MRP-169 NRC RAI Response NRC Meeting

August 23, 2007

RAI Questions & Responses

PWOL Mockup Stresses vs. Surge Nozzle WOL Calculations

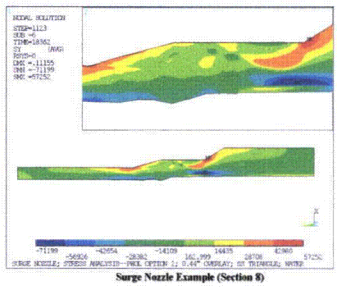
- Stress Analysis #4 – Discuss why stress distributions in mock-up PWOL are different from those in example nozzle PWOLs
- Response –
  - PWOL mockup simulates a surge nozzle. Surge nozzle stress contour plots will be added to revised MRP-169
  - Mockup residual stresses in Section 5 were reported at room temperature for comparison to XRD measurements, surge nozzle example in Section 8 was reported at operating temperature
  - Post-overlay residual stresses for mockup and surge nozzle example do not differ significantly under consistent conditions
  - Detailed stress plots are provided in RAI response that demonstrate this point
